16 November 2021

Jo-Anne Thomas
Director
Savannah Environmental

PART 2 AMENDMENT FOR KORANA SOLAR ENERGY FACILITY GRID CONNECTION: AVIFAUNA

Figure 1: The assessed grid alternatives for the Korana Solar Energy Facility. Alternative 1B is the currently approved alternative.

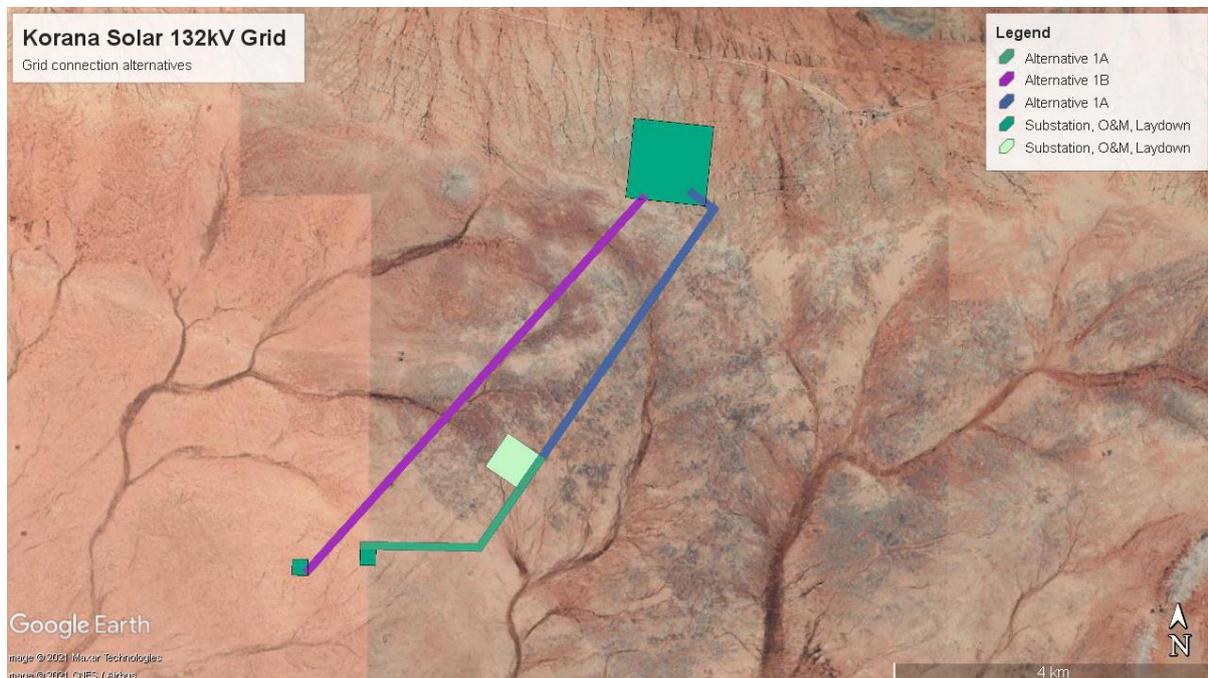
I considered the proposed amendment to the powerline routing, and my findings are as follows:

- The construction and operation of the Alternative 1A will not change the nature or significance of any of the impacts previously assessed in any significant manner.
- The construction and operation of the proposed Alternative 1A is not likely to result in any additional impacts that were not previously assessed.
- No additional management outcomes or mitigation measures in terms of avifaunal impacts would be applicable to the proposed Alternative 1A.

It is therefore recommended that the amendment is authorised from an avifaunal perspective. It should be noted that Alternative 1A was also the preferred alternative from an avifaunal perspective in the original specialist report, because Alternative 1B was deemed riskier due to its location close to a water point which increases the risk of collisions.
